30-46 AUBURN ROAD, REGENTS PARK

REVIEW OF FSR

(PP_2016_CBANK_001_00) – 30-46 AUBURN RD, REGENTS PARK, DATED 17 APRIL, 2020

FIGURE 1: BUILDING HEIGHTS

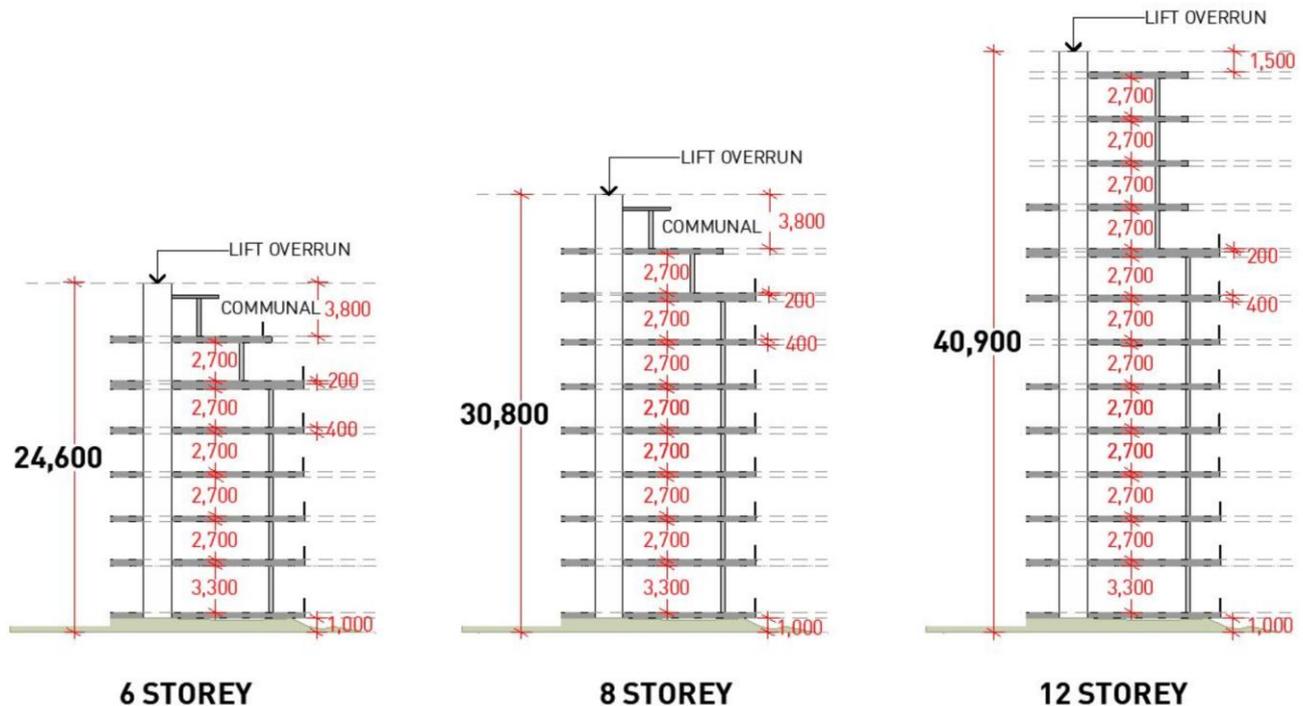
We are of the opinion that the heights nominated would not achieve the agreed number of storeys.

The heights (in storeys) proposed by the McGregor Coxall plan, and applicants version of the same cannot be achieved within the gateway determined height standards if the future development is to comply with the design criteria in the ADG.

The following diagrams represent an illustration of the building heights that allow for the following with a small margin:

- 2.7m ceiling height,
- 0.4m for services, slab and beams.
- 0.2m increase in slab for upper level setback to allow for insulation and setdowns
- 1m allowance for slope across building footprint
- 1.5m allowance for parapet and lift overrun.

We also note that ground level varies from 37.28 (centre north boundary) to 28.82 (south east corner of site). On such a large site the future ground levels around the building base may be different to existing levels as the site is graded to provide an appropriate public domain response, and interface with neighbouring properties. Additional tolerance is needed to allow for adjustments to the existing ground surface to ensure the new streets and open spaces provide the desired relationship to the new dwellings as the site transitions from industrial to residential uses. The ADG recommends that ground floor apartments be slightly elevated to a maximum of 1m above the adjacent public domain.

Additional height (particularly on the 6 & 8 storey buildings) can allow for roof top communal open space that can add to the amenity of the proposed development and allow for roof

As such we recommend that following heights would allow a development to fit fully within the height standard:

- 6 storey – 25m
- 8 storey – 31m
- 12 storey – 41m

These heights will avoid the need for cl. 4.6 variation to development standards at the development application stage.

FIGURE 2: ENVELOPES-NORTH-WEST_SUN ANALYSIS MID-WINTER

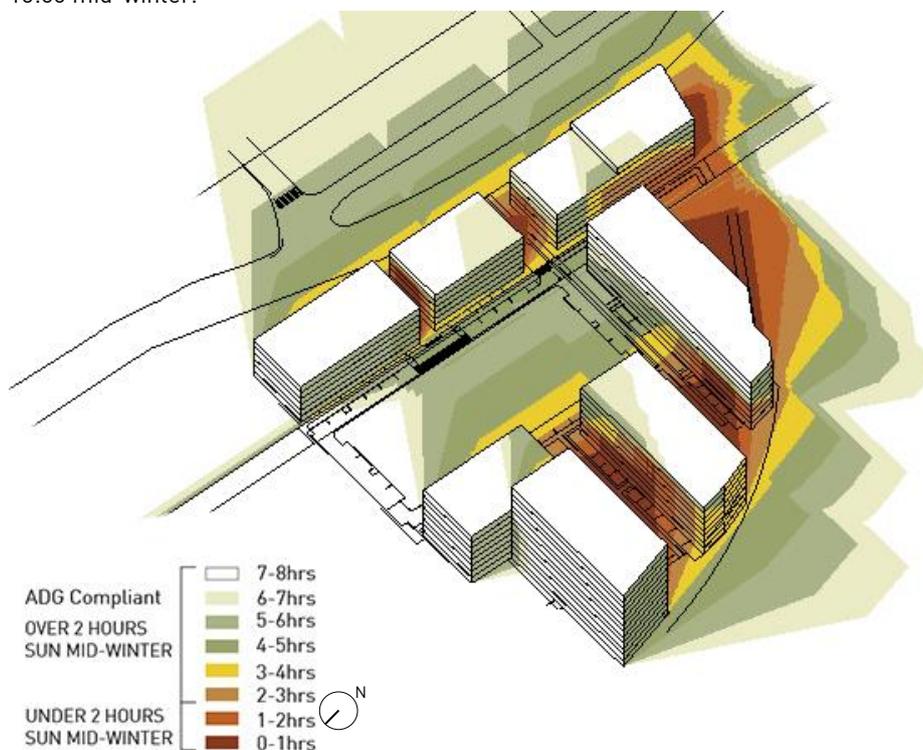
There is more than enough capacity to achieve the required solar access. The solar access analysis at Figure 2 shows that approximately 80% of the north facing building envelope and 95% of the west facing building envelope achieves at least 2 hours of sun between 9:00 and 15:00 mid-winter.

FIGURE 3: ENVELOPES-NORTH-EAST_SUN ANALYSIS MID-WINTER

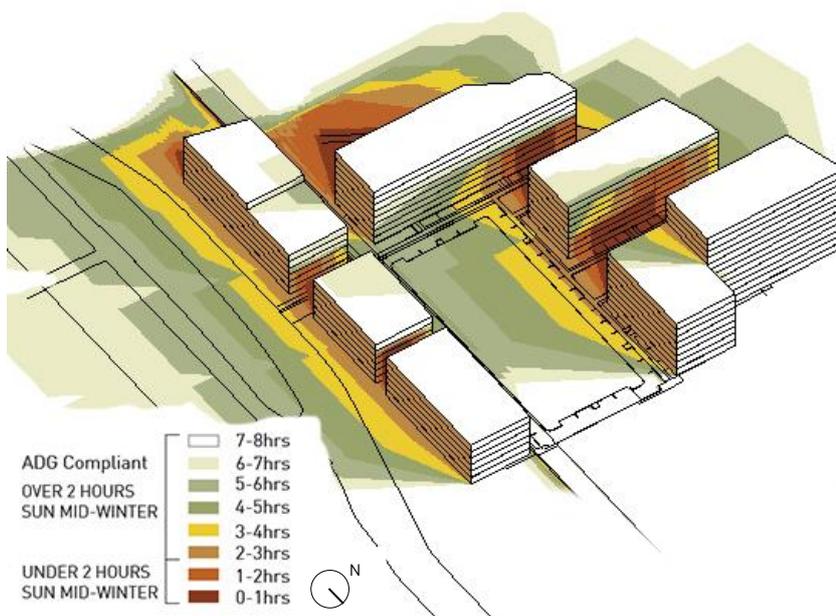
The solar access analysis at Figure 3 shows that 100% of the east facing building envelope is able to achieve just over 2 hours sun between 9:00 and 15:00 mid-winter. However compliance is marginal due to the orientation. Achieving solar access will be subject to the detailed design of the apartment layout and façade detailing. This would require apartment layouts where living room windows are flush with the main façade line and mindfulness around protruding elements on the façade, or the including of bay windows. With careful design of the eastern facades a large percentage of the east facing apartments are likely to achieve and exceed 2hrs solar in the morning.

FIGURE 4: EXAMPLE 22.4M WIDE NORTH FACING FLOORPLATE

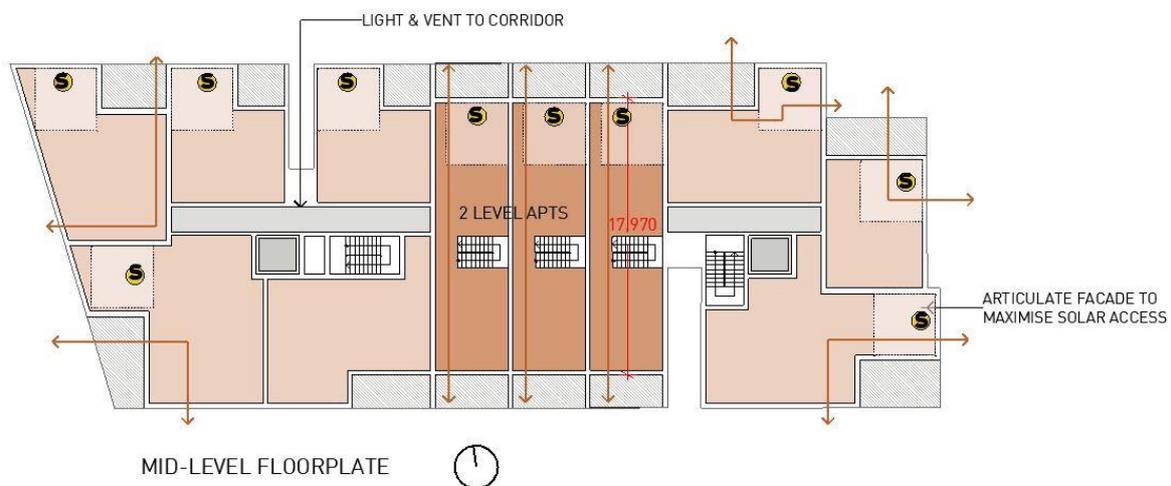
We note the Architectus analysis of the Studio MRA floorplate, we agree that this arrangement of apartment layouts would not satisfy ADG design criteria for solar access and cross ventilation. As noted earlier it is not the role of a Planning Proposal to provide a detailed assessment of apartment layouts, but ensure the controls proposed are appropriate for the site. The FSR and height proposed can accommodate a development that

meets the ADG design criteria. The plan below demonstrates a 22.4m wide floorplate layout on the site that is able to achieve 81.8% solar and 72.7% cross ventilation. Note that this may not be able to be achieved on all levels if overshadowed. This has been achieved through:

- Maximising the placement of living rooms and POS on the north and eastern facades.
- Minimising single aspect south facing apartments and locating services to the southern façade.
- Placing living rooms against the glazing line, rather than set behind deep balconies where possible.
- Designing end of floorplate apartments to cross vent on corners.
- Using cross through apartments (18m glass line to glass line maximum) with a northerly or western orientation, and cross venting through the apartment – to achieve cross vent and solar. This drastically reduces the number of apartments with a southern orientation.
- Any protruding design elements do not block solar to apartments.
- Articulate facade to maximise solar access
- Any notches or cut-outs used to achieve cross vent to apartments are of an adequate size and proportion as described in ADG Objective 4b-2.

FIGURE 5: ALTERNATE BUILDING FOOTPRINTS

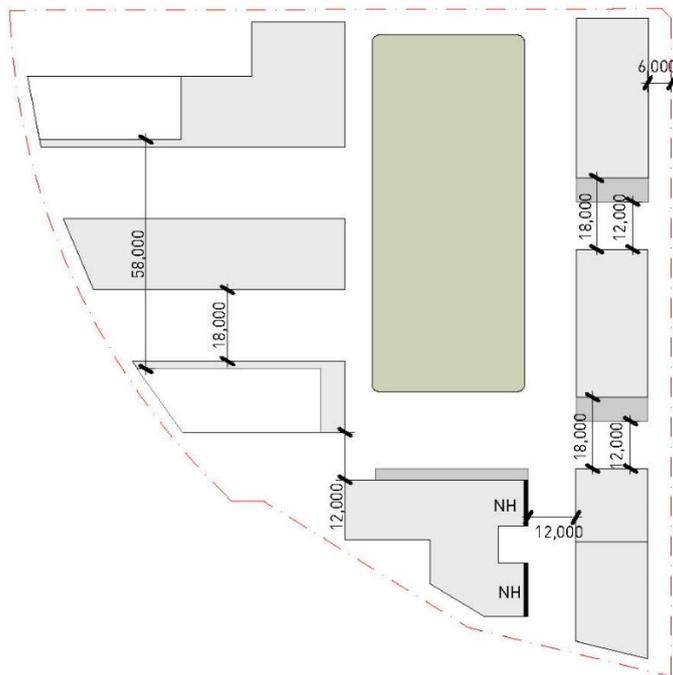
To illustrate that the masterplan has adequate flexibility to support a number of building configurations within the proposed controls while adhering to the principles of the MGCS, STZ have prepared a high-level alternate scheme. This scheme also has the ability to comply with the ADG, notably in relation to building separation, solar access, building depth, apartment layouts and cross ventilation.

This scheme demonstrates that there is sufficient flexibility in the adaptation of the MGCS to accommodate an FSR of 2.4:1 as proposed by the masterplan, while achieving good design on a precinct, building and apartment level. Though this is a high-level plan and not to the level of detail as the applicants' plan, key concerns such as building separation, setbacks, and the ability of envelopes to accommodate apartments that can comply with the ADG has been tested.

FIGURE 6: INDICATIVE FLOORPLATES 18M

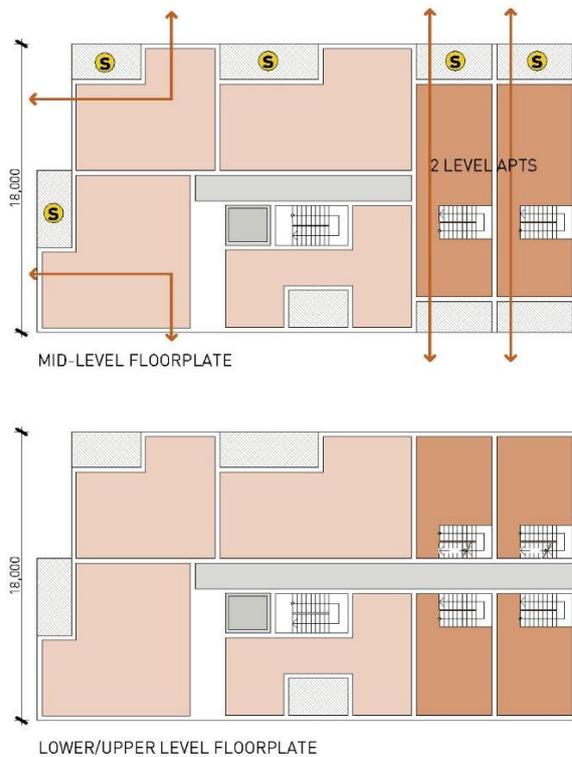
- Building depths, solar and cross ventilation performance. A reduced building depth of 18m allows more efficient floorplates, and example of which is shown below. End of floorplate apartments are able to cross vent on corners with vertical circulation and services located to the rear of the building. Two level mid-floorplate apartments can run through the building, each with a northerly or western orientation, and cross venting through the apartment. This drastically reduces the number of apartments with a southern orientation. This layout is

efficient as only the mid-level of every three requires a corridor through the length of the building. This results in a floor plate that is very likely to achieve minimum 66% cross vent.

FIGURE 7: SOLAR ACCESS MAP 9:00-15:00 MID-WINTER

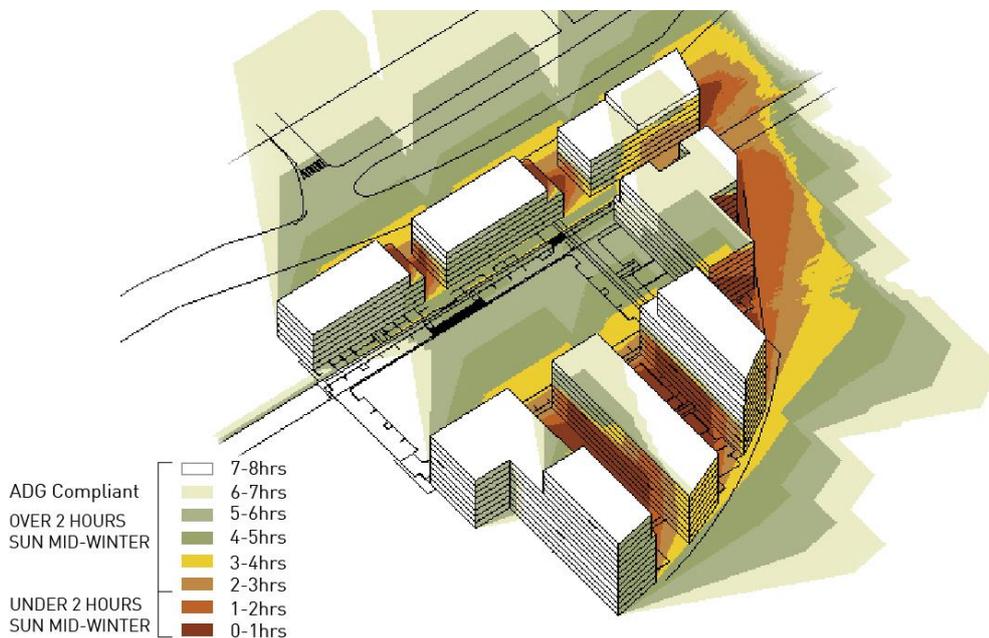
- Correct ADG building setbacks. The setbacks applied are closely linked to the ability of the alternate scheme to achieve solar. Buildings step back at 4/8 storeys, ensuring solar performance of the building envelopes.
- Solar. By reducing the building depths an additional building can be provided this has the effect of increasing north and west façade area that is able to achieve solar access. Hence having two buildings at 39m (that step back to comply with ADG building separation controls) means there are a greater number of apartments are at a higher level in the buildings facing north that can achieve superior solar, as shown in the shading diagram below.
